Coos Co. Planning Department

re: rebuttal to Jordan Coves 10/14/19 submittal under Coos County file #HBCU-19-003

Exhibit 21
Page 1 of 1

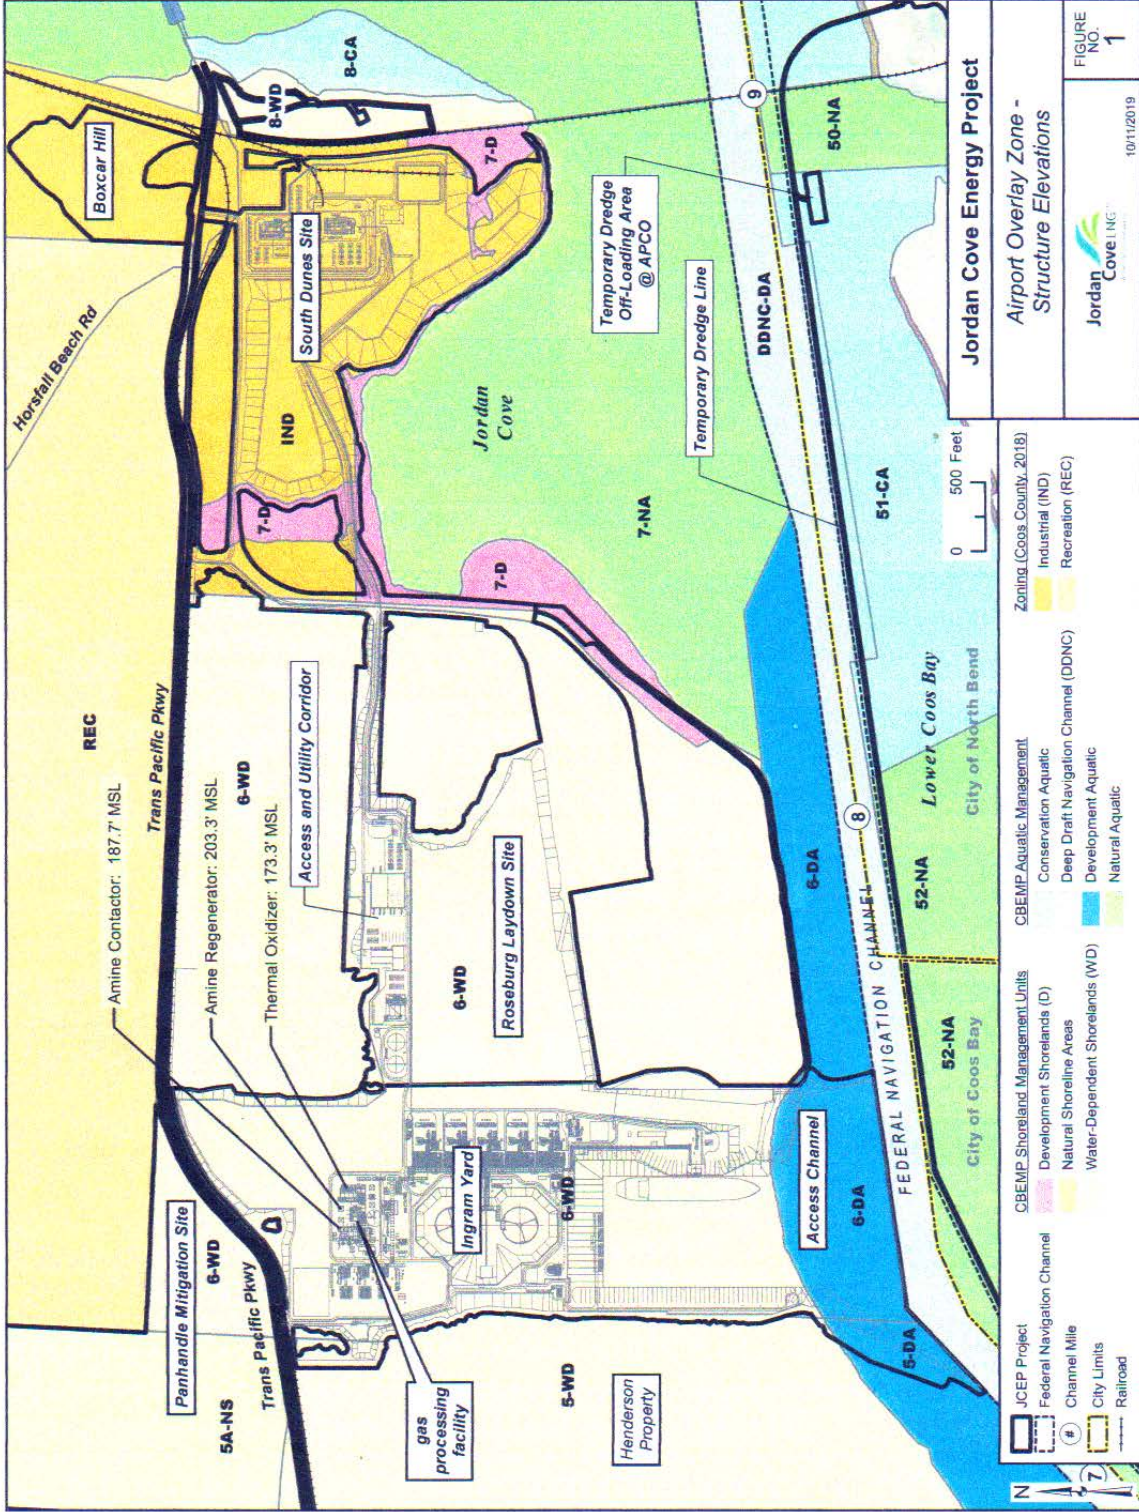
Enclosed is Jordan Coves exhibit 21 from page 4282 showing structure elevations. This is incomplete because it is missing the vent stack as referenced on page 33 of Jordan Cove's Certificate Exemption Application to the Department of Energy dated June 14, 2018 (exhibit 1). The Vent stack is also missing from the FAA aeronautical study dated September 3, 2019 (exhibit 2)¹.

¹ Please Note grade is 42 ft. above mean sea level making the total height of 172 feet.
